CITY OF ANN ARBOR, MICHIGAN

ADDENDUM NO. 1

Bid: Construction services to remodel the sixth floor offices at the Guy Larcom Municipal Building (Ann Arbor City Hall)

Bid No: ITB-3867

SK-1

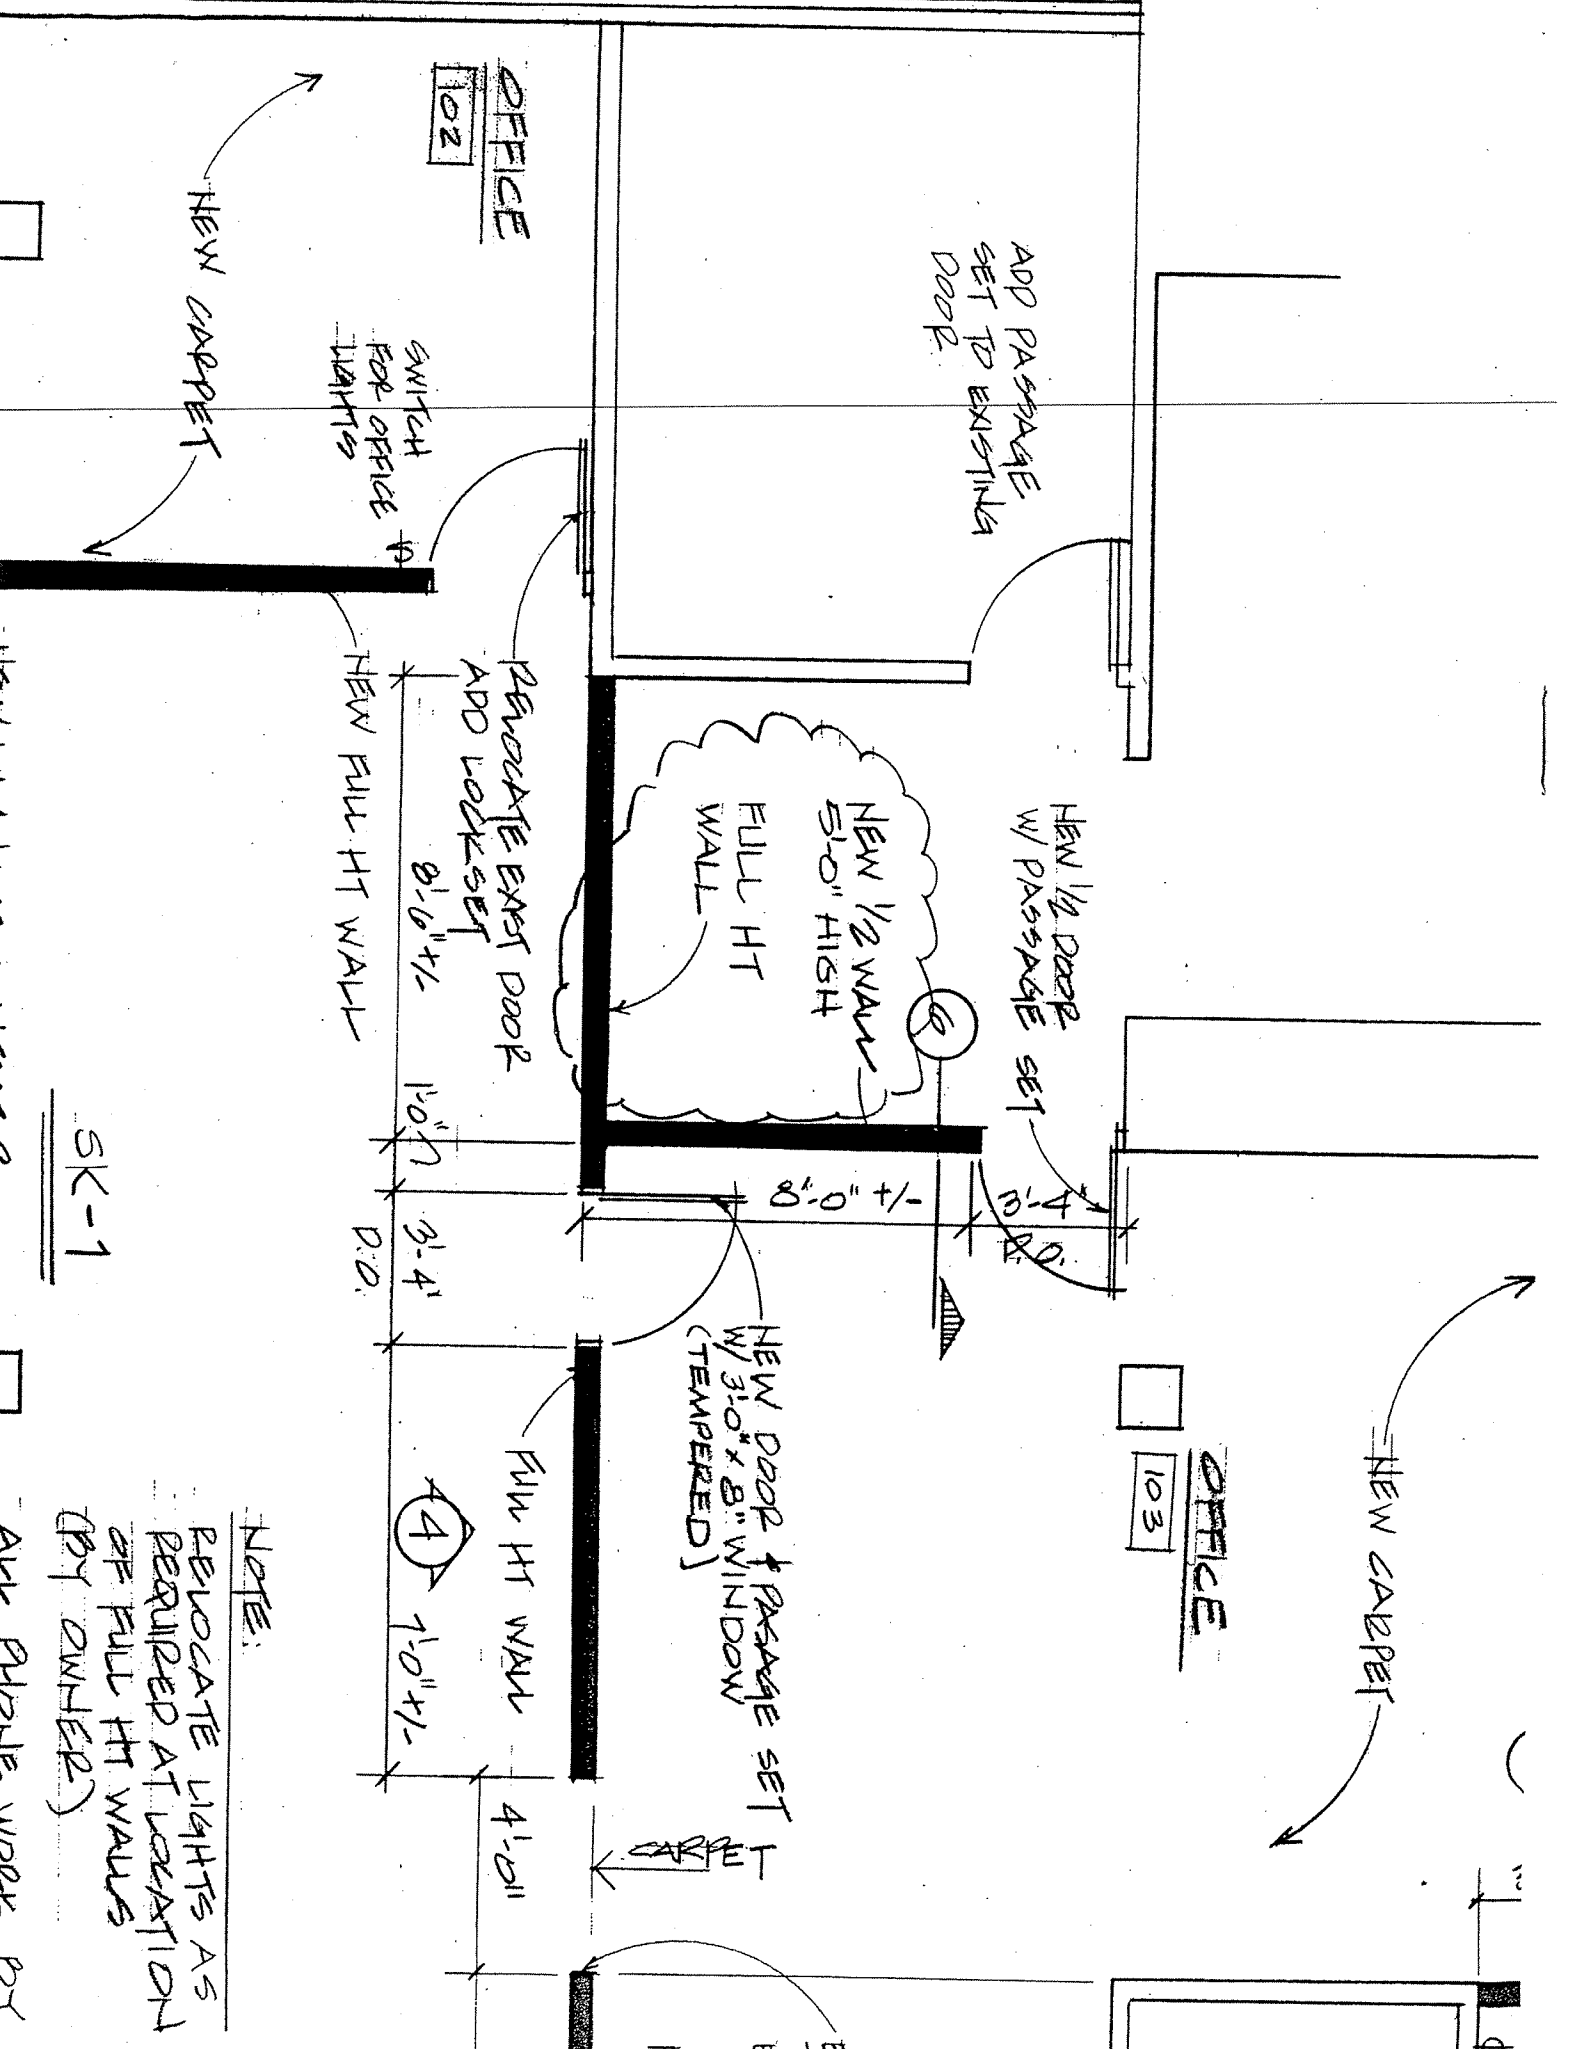
Refer to sheet SK-1. Approximately 10 feet of wall in Office 103 has been changed from a half wall to a full height wall.

NOTE:
 RELOCATE LIGHTS AS
 REQUIRED AT LOCATION
 OF FULL HT WALLS
 (BY OWNER)
